Town of Rolesville, NC
Department of Planning

Comments on #CID-26-0006 - Planning & Zoning: Construction Infrastructure Drawing

Application Number: #CID-26-0006
Application Type: Construction Infrastructure Drawing
Date: May 27, 2026
Address: 0 Rolesville Rd

SHEET NO.:
C10.0

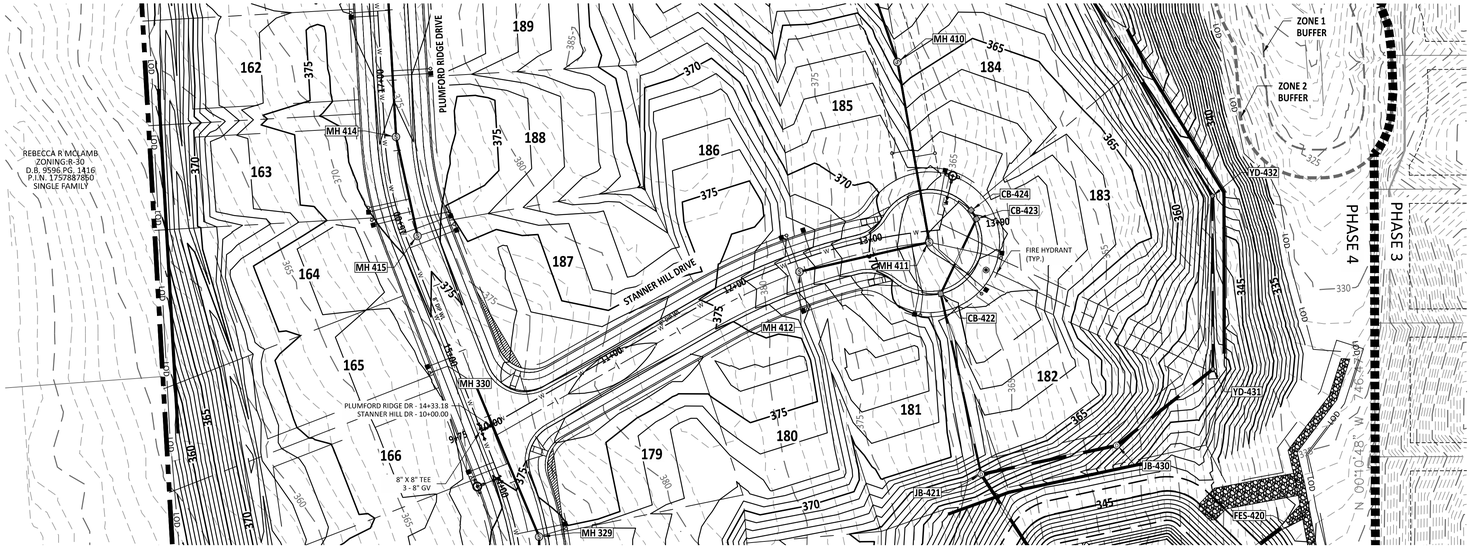
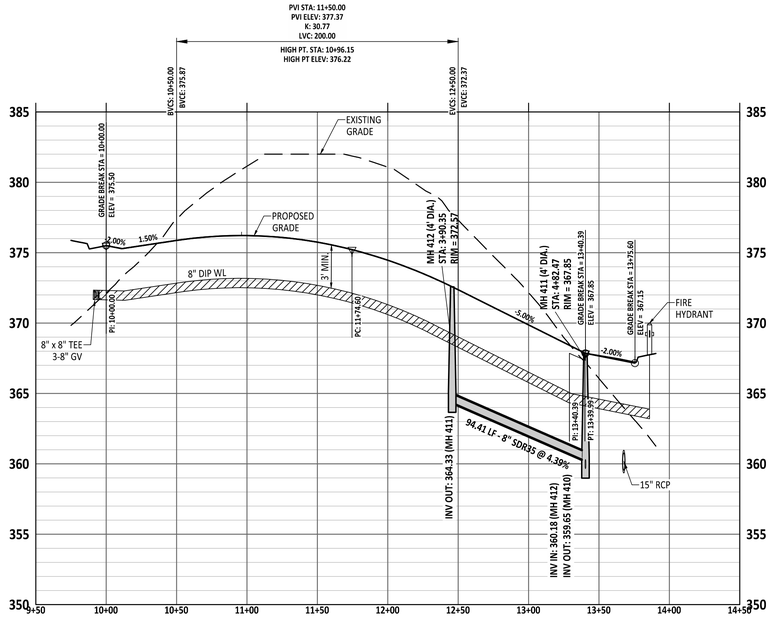
48 **Jacqueline Thompson**
Minimum K Value is 30, unless at a stop condition. Consider combining these 2 curves into a longer one to meet these requirements.

SHEET NO.:
C13.0

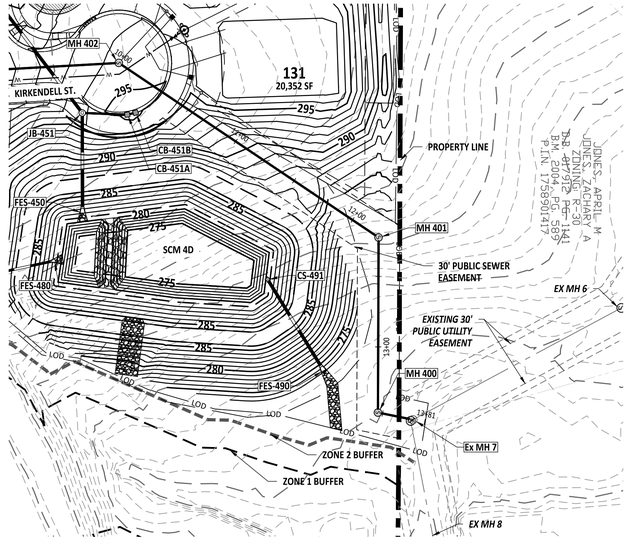
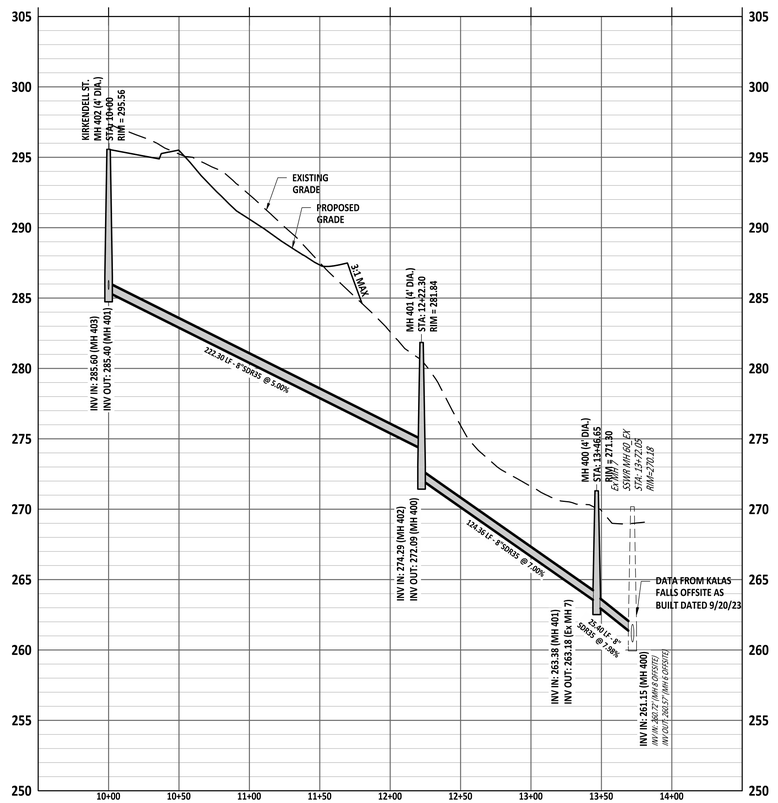
52 **Jacqueline Thompson**
With these steeper ditches, please include the velocity calculations in the stormwater package to ensure grass ditches won't erode away - riprap or concrete may need considered.
